## **Proposal for amendment to Regulation No. 46 (Devices for indirect vision)**

The modifications to the current text and (the adopted proposal ECE/TRANS/2016/9) of UN Regulation No. 46 are marked in bold for new characters and strikethrough for deleted characters.

Figure 11

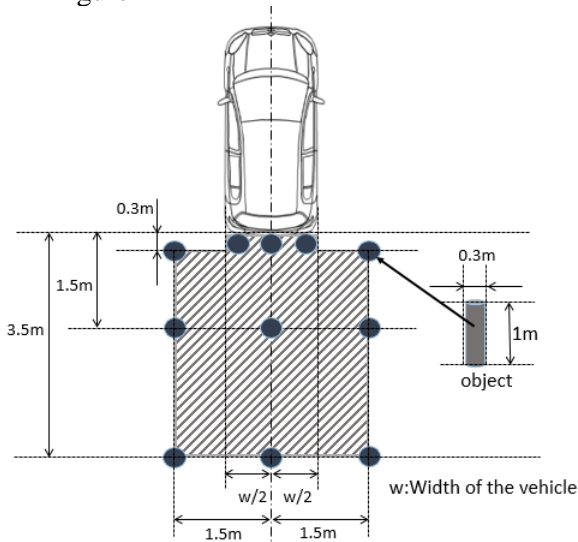
*Insert new Figure 11:*

**" Class VIII field of vision**

- "15.2.4.8. Class VIII close-proximity rear-view device**
- 15.2.4.8.1. The field of vision shall be bounded by the following planes and shall be such that the driver can see at least part of cylindrical objects with a height of 1,000 mm and a diameter of 300 mm whose centre is located within the boundaries of the field of vision:**

- (a) A transverse vertical plane through the outermost point of the rear of the vehicle;
- (b) A transverse vertical plane 3,500 mm behind the plane defined in (a);
- (c) Two longitudinal vertical planes parallel to the longitudinal vertical median plane of the vehicle, each of which is situated at a distance of 1,500 mm from that plane on either side, respectively; and
- (d) For the area between the two longitudinal vertical planes defined in (c) and within the width of the vehicle, a transverse vertical plane 300 mm behind the plane defined in (a).

**15.2.4.8.2.** If the field of vision defined in paragraph 15.2.4.8.1. can be perceived via a combination of devices for indirect vision of other Classes or directly, it is not mandatory to equip the vehicle with a Class VIII close-proximity rear-view device. In addition, the requirement may be met using a combination of mirrors of Class VIII and other Class(es) or using an obstacle detection system."
